**HYDROLOGY DEVELOPMENT SECTION  
DEVELOPMENT REVIEW BOARD MEMO**

**DRB PROJECT NO: 1009090**

**Re: ADS Office Building Conceptual Grading Plan**  
**Engineer's Stamp dated 5-4-07 (C13/D25E)**

PROJECT TITLE: ADS Office Building

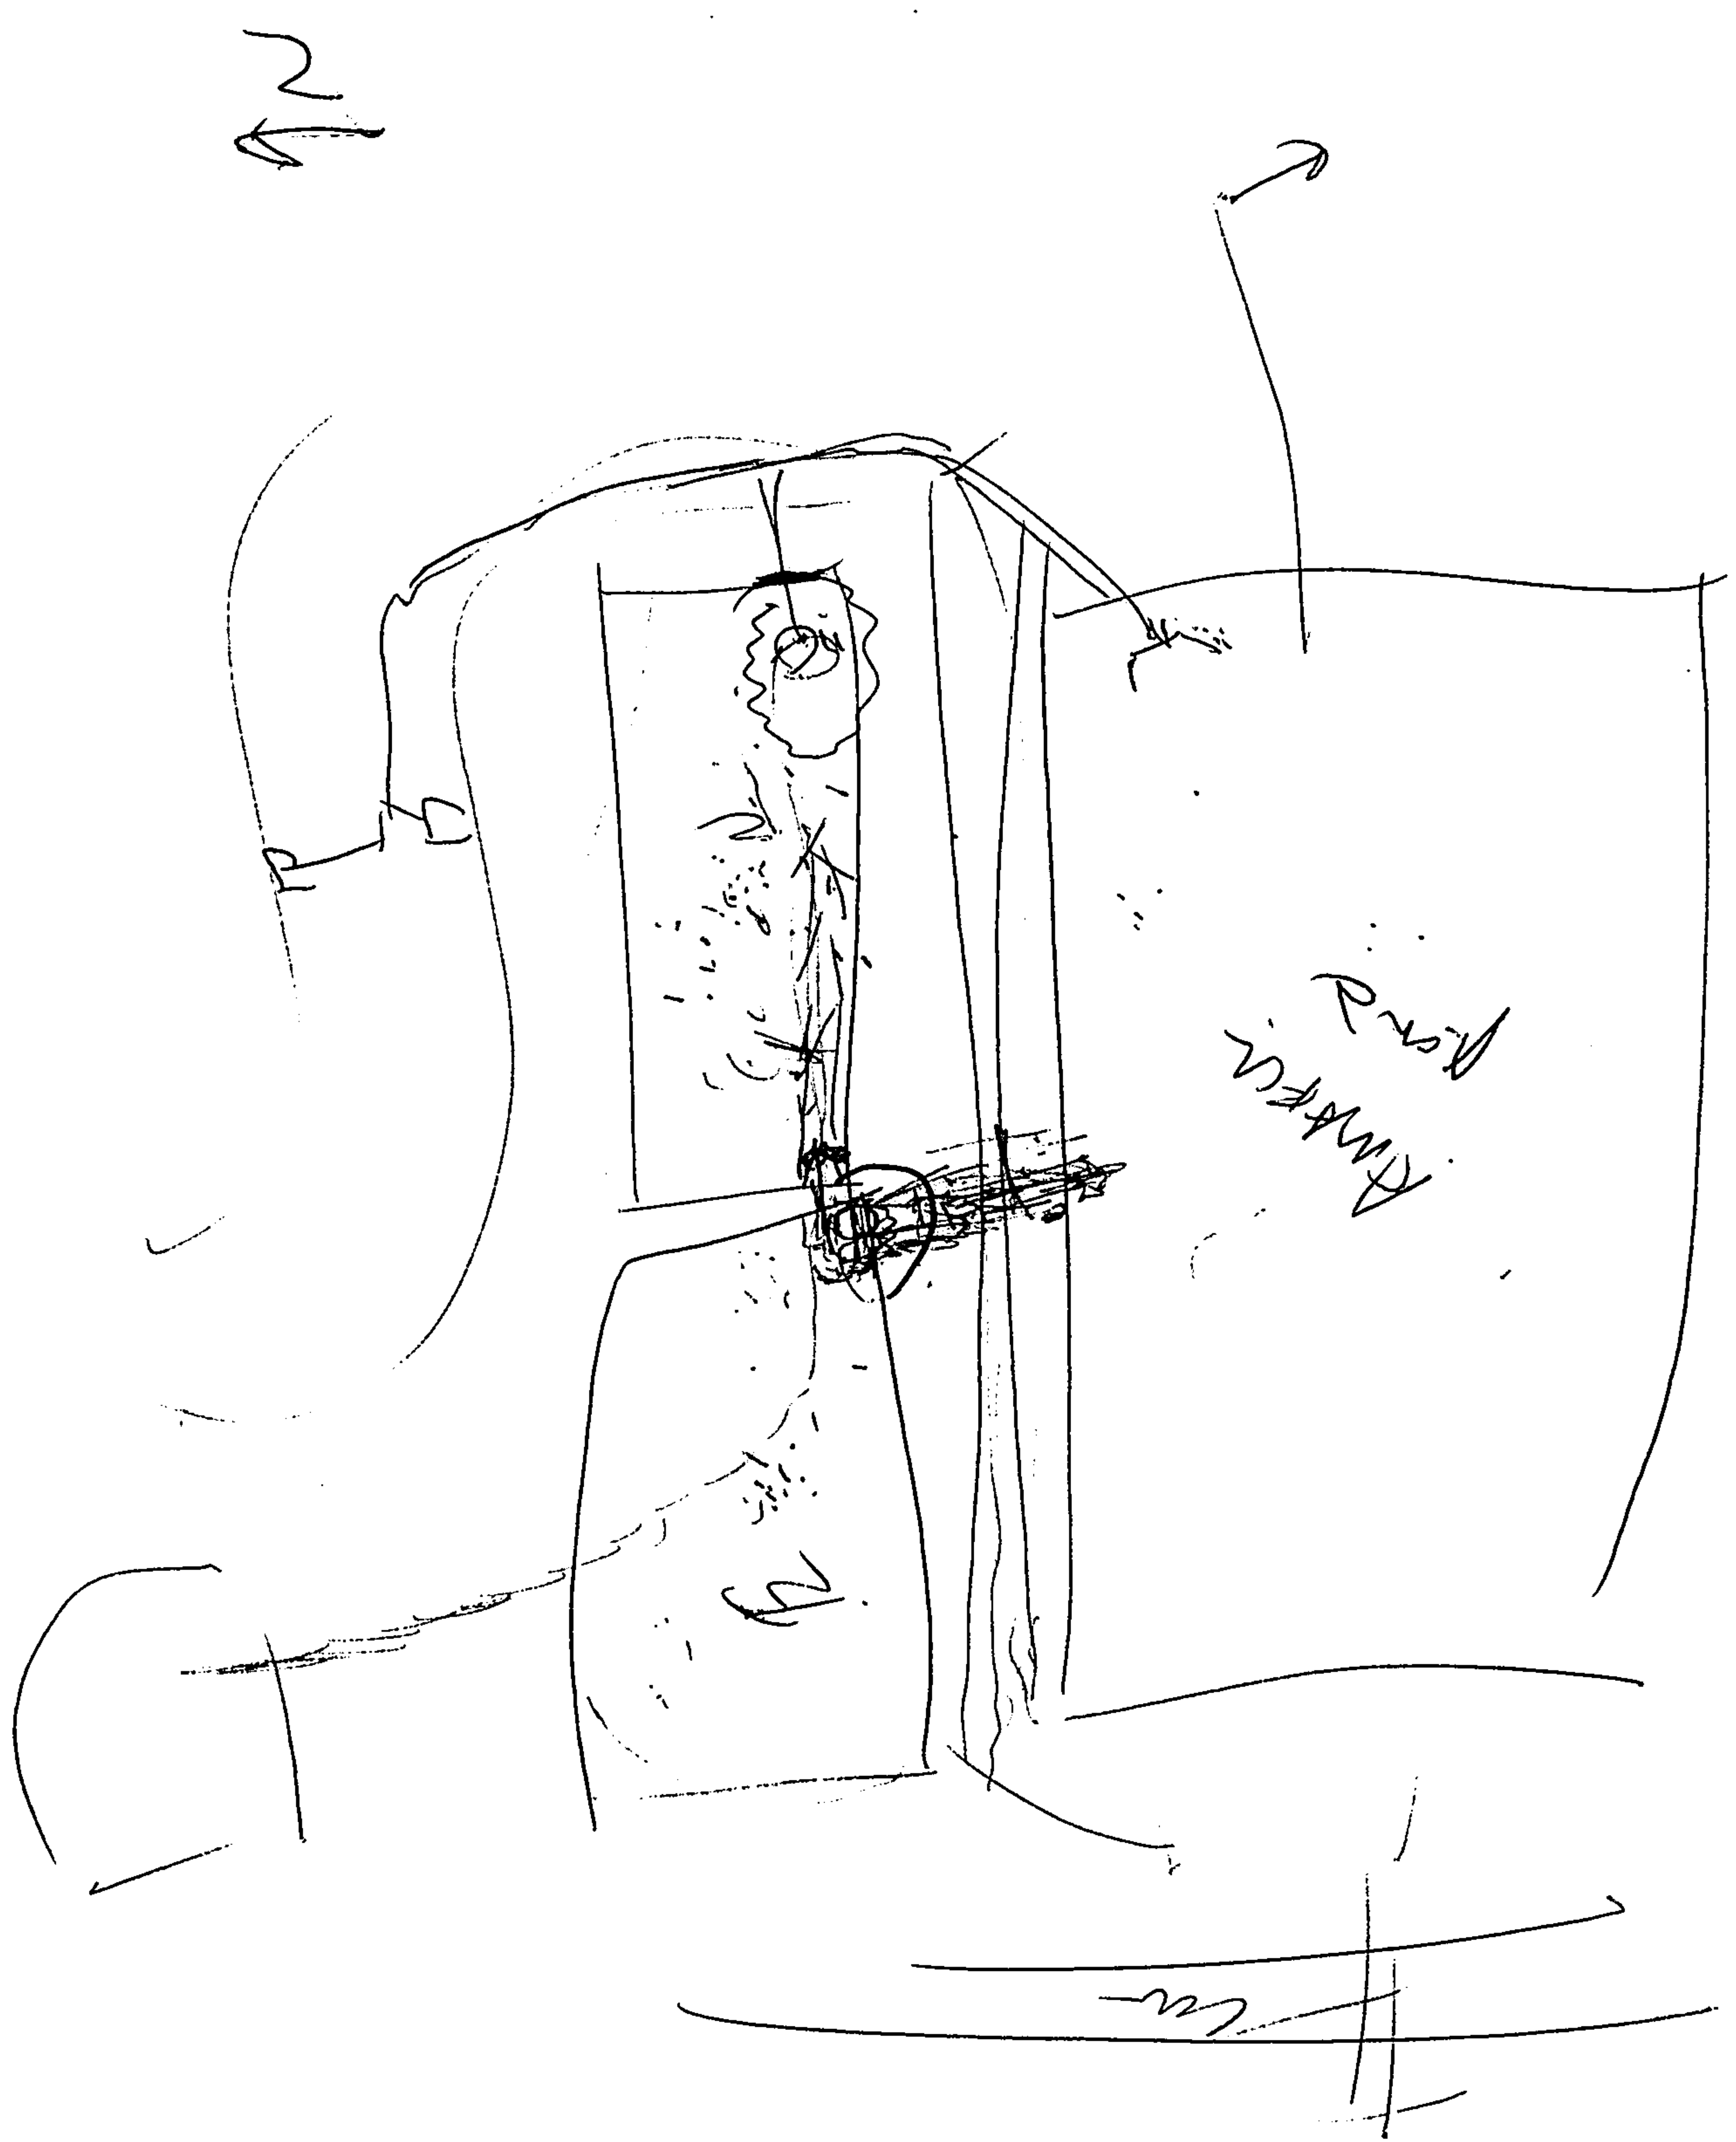
Hydrology is still working with the engineers on the drainage report.

Changes to the public storm drain system should be included on the infrastructure list. This should be limited to adjusting manhole rims to the proposed grade.
